PRODUCT/PROCESS CHANGE NOTICE (PCN)

PCN #: A1804-01 DATE: 18-Apr-2018 Product Affected: TSE2004GB2C0NCG TSE2004GB2C0NCG8 Date Effective: 18-Jul-2018	MEANS OF DISTINGUISHING CHANGED DEVICES: <input type="checkbox"/> Product Mark <input type="checkbox"/> Back Mark Assembly lot# prefix: <input type="checkbox"/> Date Code "TF" denote TFME, China <input checked="" type="checkbox"/> Other "HT" denote HTC, China
--	---

ATTACHMENT 1 - PCN # : A1804-01

PCN Type: Manufacturing Site - Alternate Assembly, Test & Backend Location

Table 1: Carrier Tape Comparisons

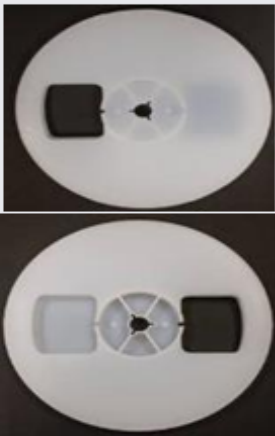
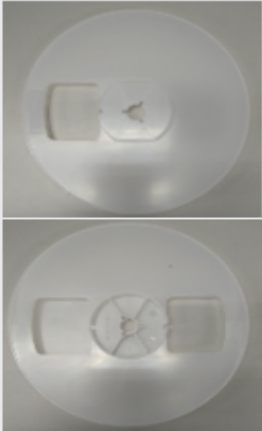
Carrier Tape and Plastic Reel comparisons (Carsem and TFME, China)

Carsem, Malaysia	TFME, China
Part Number	C-PAK BD0200x0300	ECA1941-PS-BLK-520
Ao	2.3+0.1mm	2.3+0.05mm
Bo	3.2+0.1mm	3.2+0.05mm
Ko	1.0+0.1mm	1.0+0.05mm
P	4.0+0.1mm	4.0+0.1mm
W	8.0+0.3mm	8.0+0.2/-0.1mm
Drawing	Refer Page 7	Refer Page 8
Snapshot

Table 3: Carrier Tape Comparisons

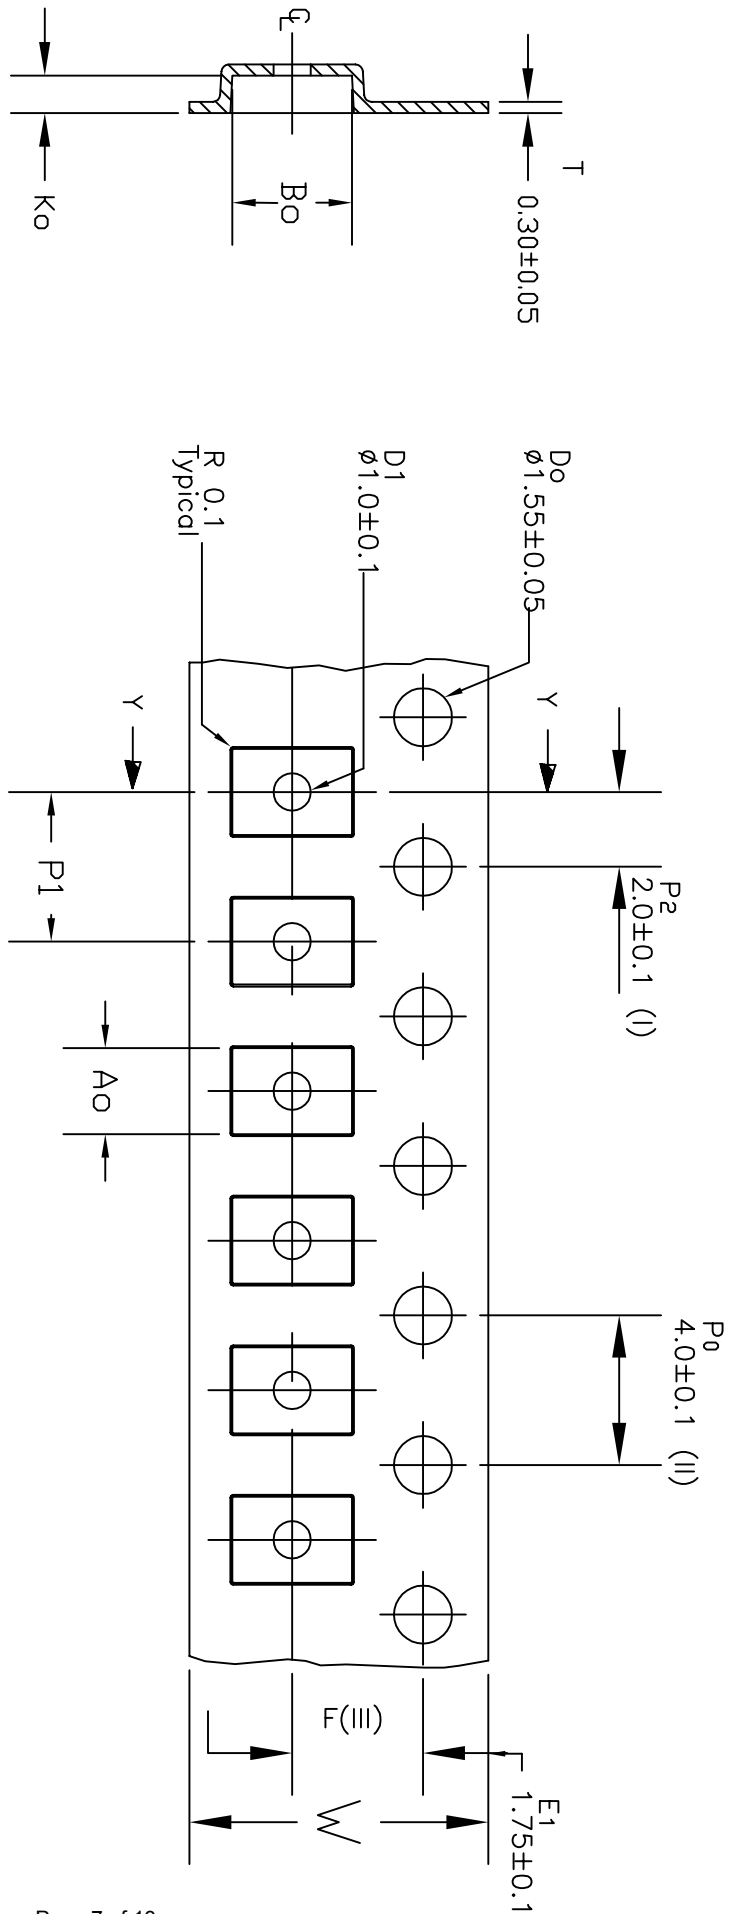
Carrier Tape and Plastic Reel comparisons (Carsem and HTC, China)

Carsem, Malaysia	HTC, China
Part Number	C-PAK BD0200x0300	ECA1941-PS-BLK-520
Ao	2.3+0.1mm	2.3+0.05mm
Bo	3.2+0.1mm	3.2+0.05mm
Ko	1.0+0.1mm	1.0+0.05mm
P	4.0+0.1mm	4.0+0.1mm
W	8.0+0.3mm	8.0+0.2/-0.1mm
Drawing	Refer Page 7	Refer Page 12
Snapshot

TFME Reel

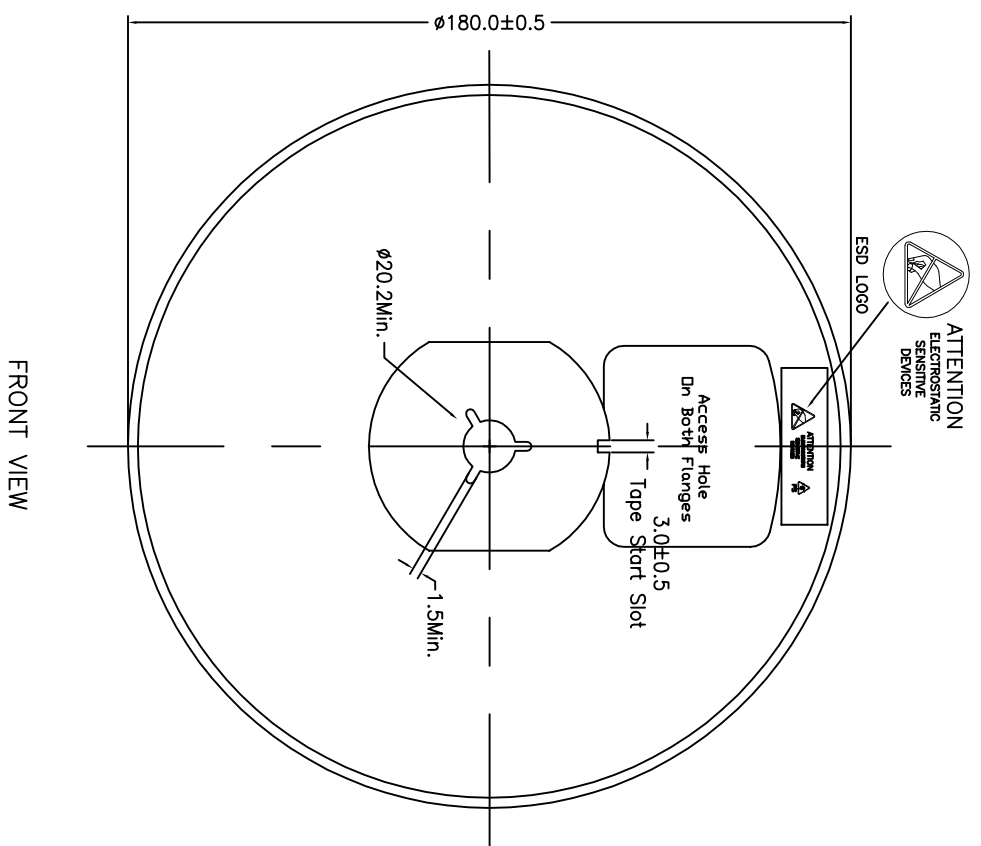
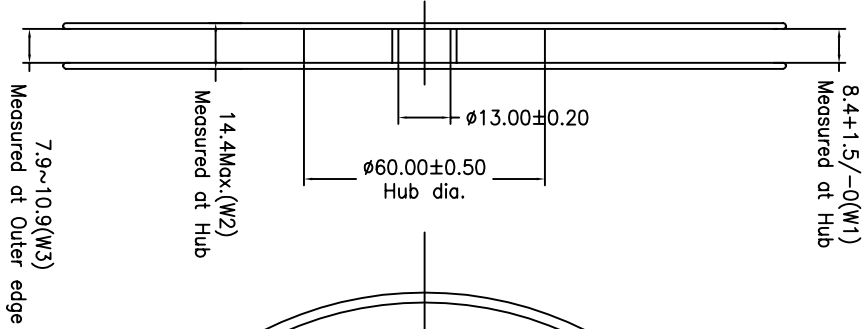
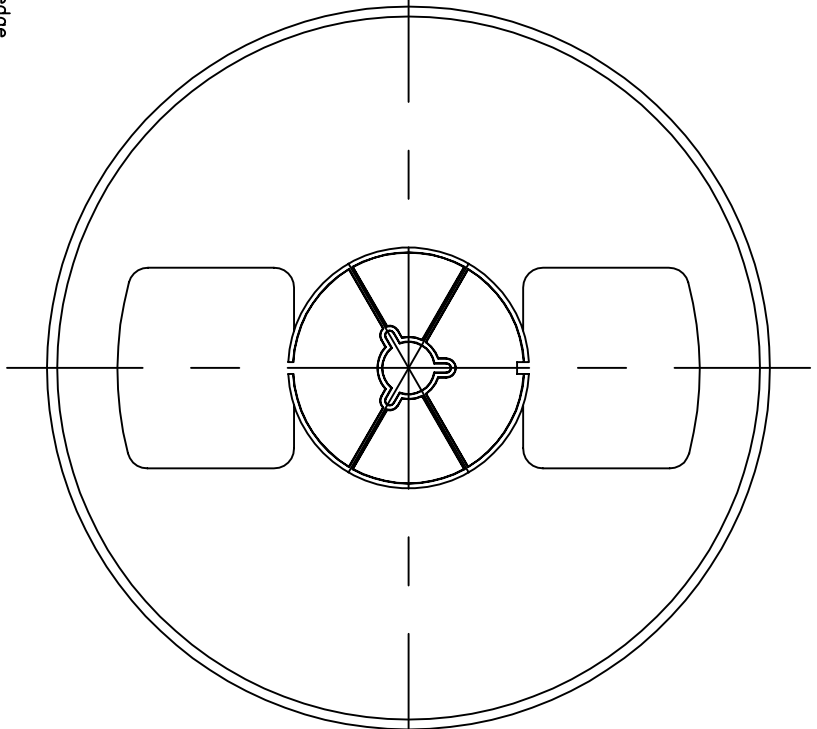
Carsem, Malaysia	TFME, China
Part Number	NEWTECH P9-065-000 White	E-PAK eRL0126-T08-A47-TRL
Reel Dia	7"	7"
Hub Dia	2"	2"
Drawing	Refer Page 9, 10	Refer Page 11
Snapshot

TITLE: 7" PLASTIC REEL FOR 8 MM		SCALE N/A	
STOCK NO. N/A	DRAWING NO. MSC-8402-A	REV 00	SIZE N/A
DO NOT SCALE DRAWING		SHEET 1 OF 1

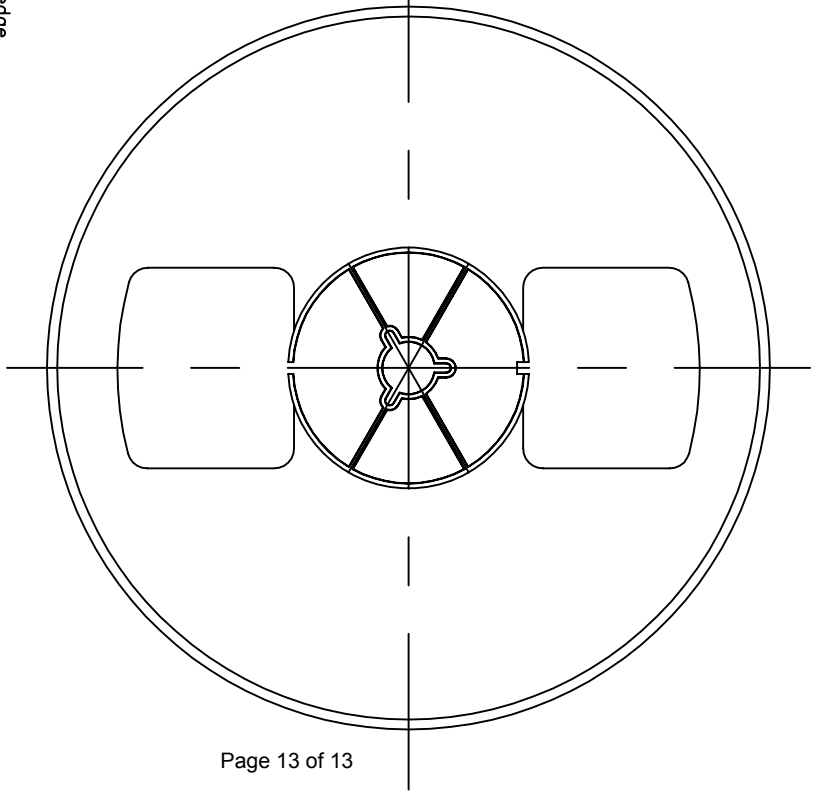
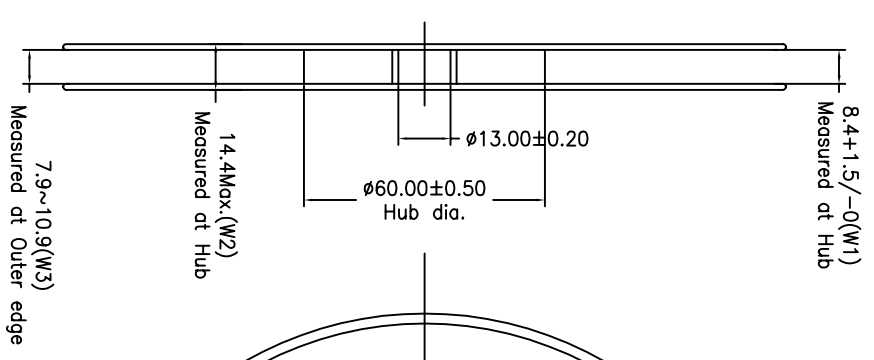
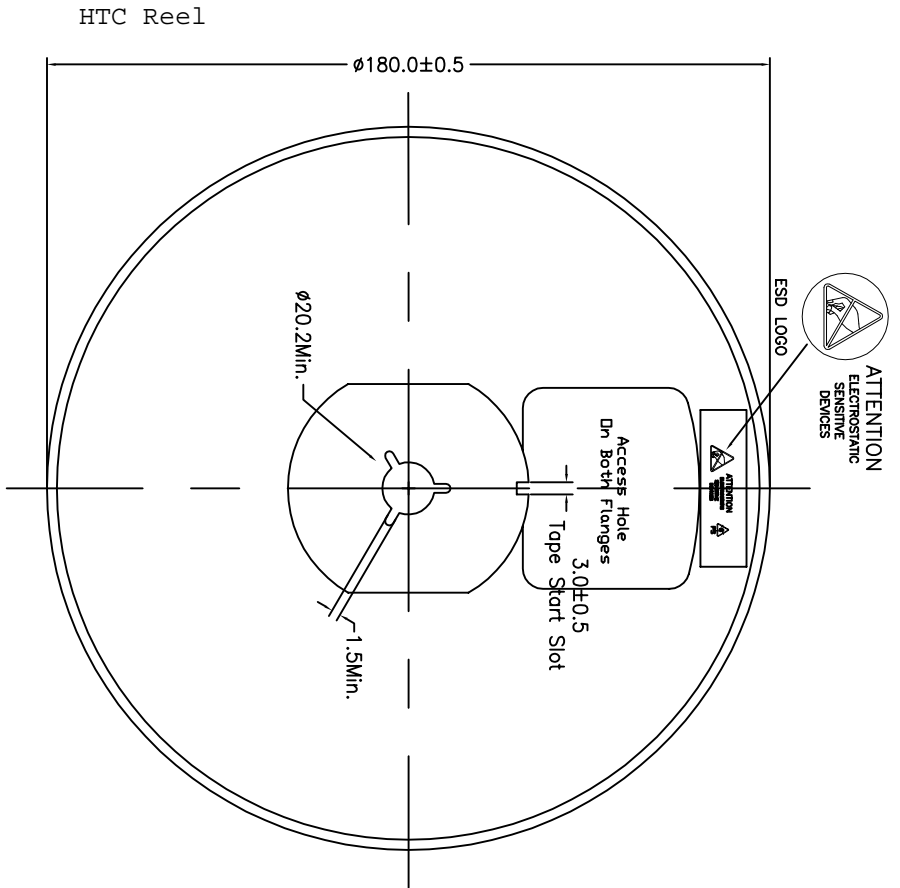
Carsem, Malaysia	HTC, China
Part Number	NEWTECH P9-065-000 White	E-PAK eRL0126-T08-A47-TRL
Reel Dia	7"	7"
Hub Dia	2"	2"
Drawing	Refer Page 9, 10	Refer Page 13
Snapshot
